Agency Correspondence

Section	Page
G-1 United States Fish and Wildlife Service	G-5
G-2 Federal Aviation Administration	G-17
G-3 New York State Department of Environmental Conservation	G-267
G-4 New York State Parks, Recreation, and Historic Preservation	G-281
G-5 New York State Public Service Commission.....	G-293

Figure 10-1A: Interconnect Substation
Maximum Project-Only L₁₀ Sound Levels
Vestas V126-3.45 MW (11m/s at 87m HH)

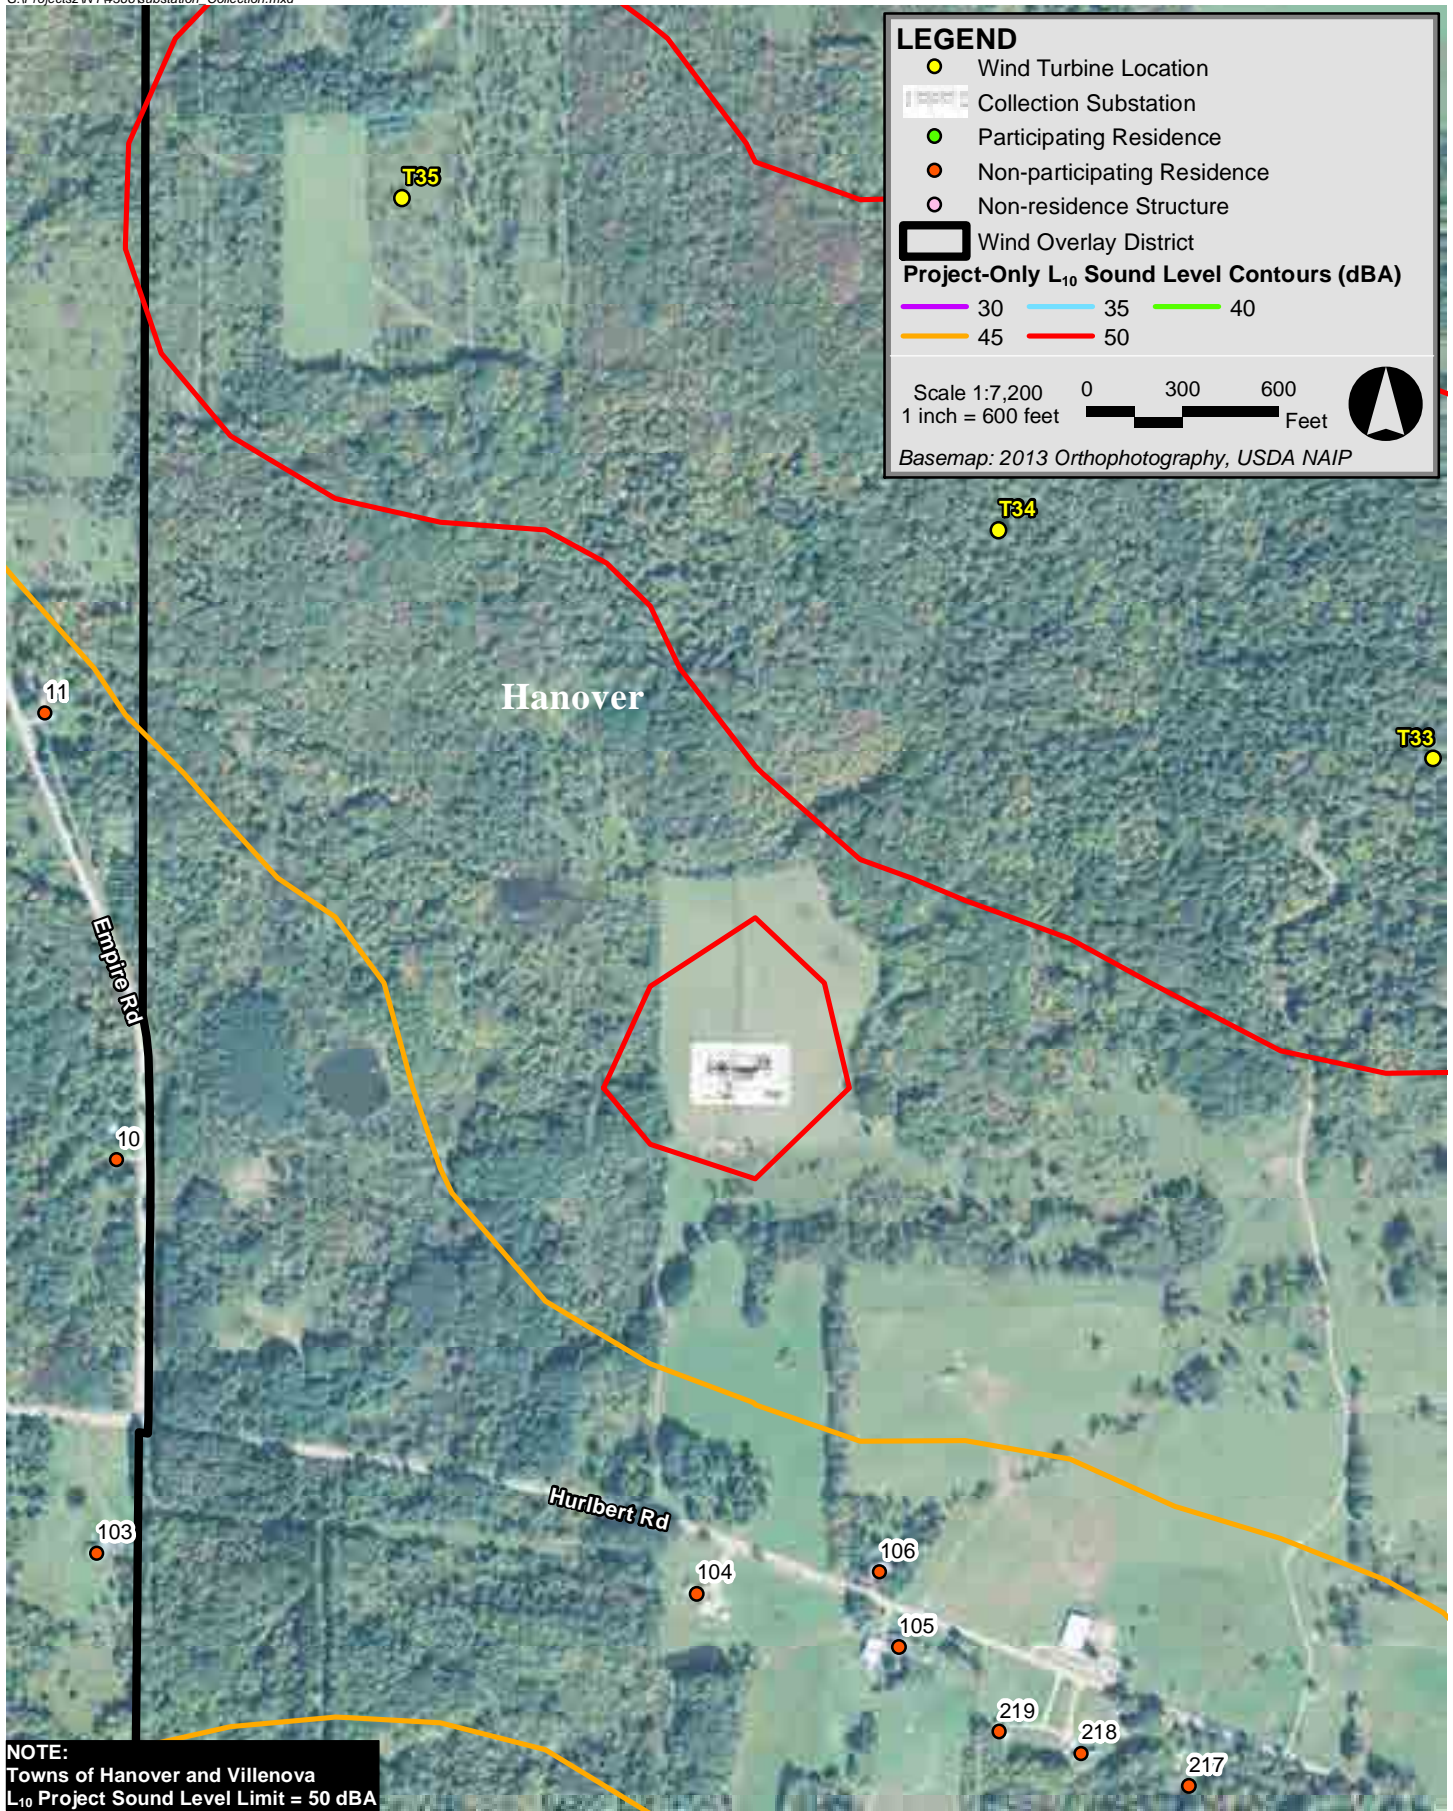
Comment 10: Figures 6-1 and 6-2 show the 50 dBA noise contour line very close to adjacent noise sensitive receptors: Provide expanded figures to show in better detail, proposed noise sources within the substation site, site property boundaries, and adjacent noise sensitive receptors.

Response 10: The attached Figure 10-1A and Figure 10-1B are zoomed-in from Figure 6-1 in the most recent sound level assessment report cited earlier in this response (rev. October 4, 2016). Figure 10-1A is the interconnection substation located at the northern edge of the Wind Overlay District, and Figure 10-1B is the collection substation located in the center of the project north of Hurlbert Road.

Comment 11: Figures 6-1 and 6-2 show the 50 dBA noise contour line very close to adjacent noise sensitive receptors: Specify any increase in ambient levels based upon existing L90 ambient noise levels and forecasted ambient levels from the substation at the most impacted sound sensitive receptors including and excluding noise levels from the closest proposed wind turbines.

Response 11: The nearest ambient sound level monitor to the collection substation was "Monitor 5" located near #9830 Dye Road just south of the Villanova/Hanover town line. "Monitor 5" is approximately 1.25 miles from the substation transformer. As seen in Figure 2.5.1 in the July 16, 2008 monitoring study ("Hessler Report"), the existing L90 ambient sound level is not a single number but varied by more than 30 dBA (~ 25 dBA to ~ 58 dBA) over the course of two weeks. For worst-case sound level impacts from the wind farm, wind speeds will be at 7 m/s at 10 meter reference height (10 m/s at hub height of 87 meters AGL). The existing L90 ambient at a 7m/s wind speed in the area is 34 dBA (Table 2.7.1 in Hessler Report).

Table 11-1 below summarizes the most impacted sensitive receptors around the collection substation as shown in Figure 10-1B, with and without contributions from the wind turbines. The nearest receptor to the transformer is ID #106 at 1660 feet. It should be pointed out that comparing a project Leq sound level to an ambient L90 sound level is not reasonable. As discussed in the October 4, 2016 sound study, the Leq background for a 7 m/s case is 44 dBA, or 10 dBA higher than the L90.

Figure 12-1. Noise Level Rank Curves for Modified CNR Rating System -- Receptor 177

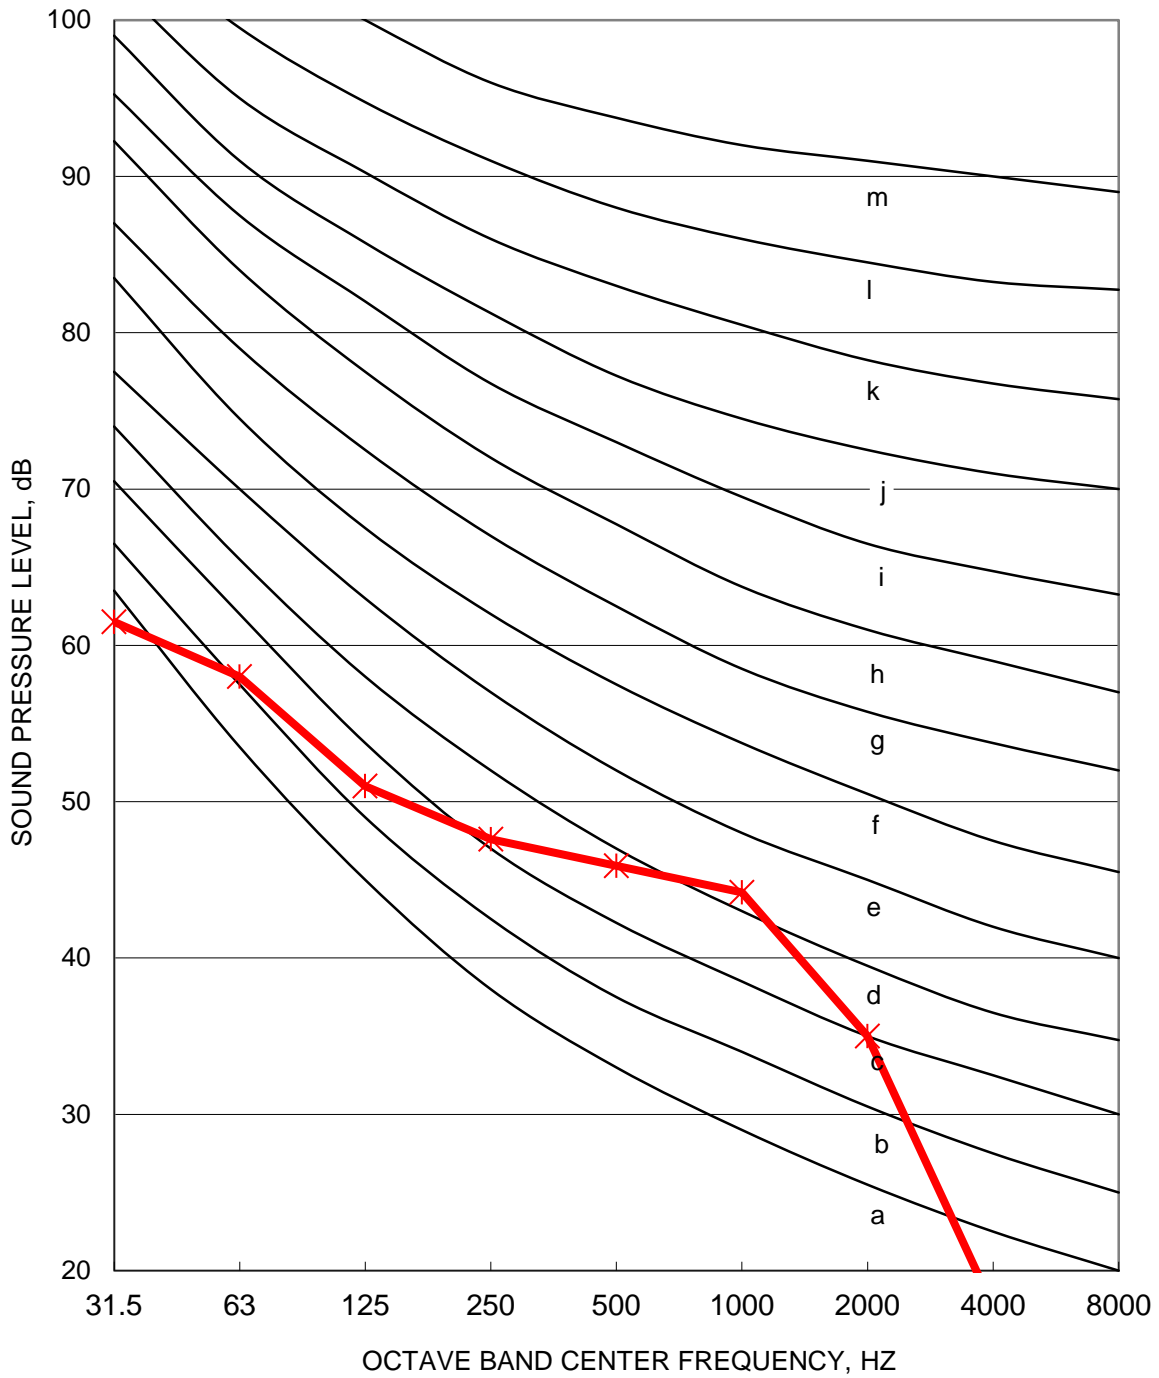
Comment 12: Figures 6-1 and 6-2 show the 50 dBA noise contour line very close to adjacent noise sensitive receptors: Estimate potential for annoyance and complaints from noise emissions at the closest noise sensitive receptors including any corrections for tonality, if applicable. Briefly explain and provide justification for the use of selected methodology for assessment of community noise reaction.

Figures 12-1 and 12-2 display the noise level rank of receptor IDs #177 and #376 respectively. These ranks are “e” and “d” respectively. Although actual octave band background L90 data are not available, the technique in Table 2-4 of the Hoover & Keith “Noise Control for Buildings and Manufacturing Plants” contains a discussion of the Modified CNR method, and provides an estimated background correction based on general land-use and vehicular traffic in the area. Receptor #176 is within 300 feet of an intermittent light traffic road, while receptor #376 is within 1200 feet of the NY State Thruway (I-90). The character (tonality) of the sound from the substation at #376 was assumed to be “not tonal” as per the response to question 6 above. In regard to step 5 “previous exposure/attitude”, the area around #177 is largely agricultural and thus has been subject to farm machinery noise for many years, the local farmers are supportive of the project, and there are many operating wind turbines in the vicinity of these towns so they are not completely unique. The area around #376 does not have an existing substation so it was corrected for “no prior exposure” to this type of source.
